*Discussion on Paper No. 6657****Standards for lowland drainage and flood alleviation and drainage of peat lands,
with special reference to the Crossens Scheme**

Tadeusz Marian Prus-Chacinski, M.Sc., Ph.D., M.I.C.E.

William Brown Harris, M.I.C.E.

FIG. 21

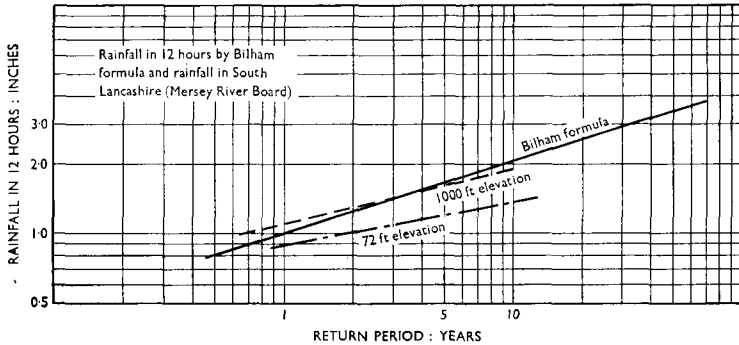
171. Fig. 21 illustrated the 12-hour rainfall and the frequency of that rainfall. For a low elevation the line was much below one calculated from the Bilham formula, whereas one at 1000 ft was very similar to the Bilham formula.

FIG. 22

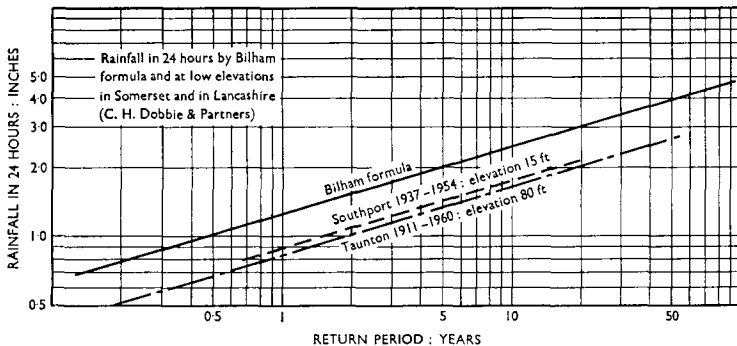
172. Fig. 22 was the same story for 24 hours. The uppermost line was from the Bilham formula. Of the two lower lines, one was for Southport and the other for Taunton in Somerset. It seemed that the intensity of rainfall at low elevations was lower than that at high elevations.

FIG. 24: DRAINS AND SMALL DITCHES IN PEAT

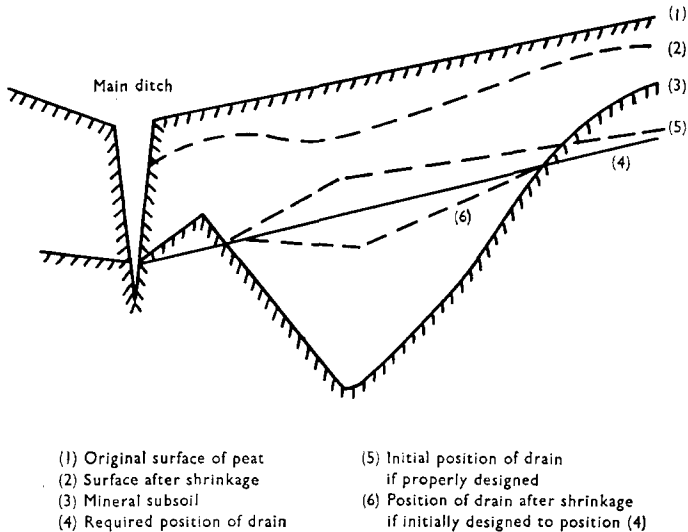
194. Fig. 24 was a sketch which showed that if the shrinkage was taken into account, the line of the drain could be designed in such a way that after shrinkage there would be no kinks. That was very helpful and this sort of design would certainly prolong the useful life of a drain.

FIG. 25: SHRINKAGE OF PEAT DUE TO DRAINAGE

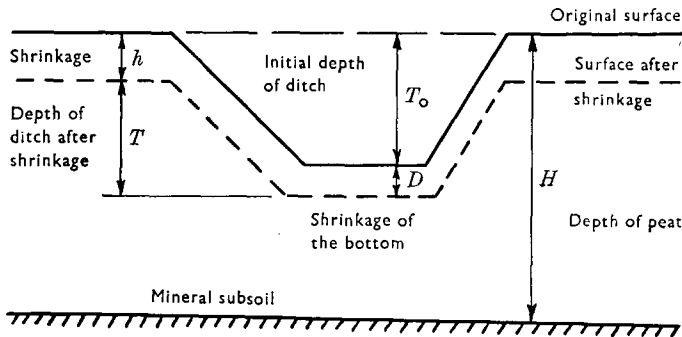
195. Regarding the shrinkage of peat due to drainage, there were two independent phenomena: (i) wastage of peat surface due to several causes, and (ii) shrinkage proper due to the collapse of the peat fabric. Fig. 25 showed that peat shrank not only above the water table but below the water table. It was often difficult to convince people of this, but unfortunately it was true. The explanation was that when

a ditch or drain was dug, water drained out of the top layers, which then slowly collapsed and pressed on the lower layers, squeezing water into the ditch, so that there was shrinkage below the water table.
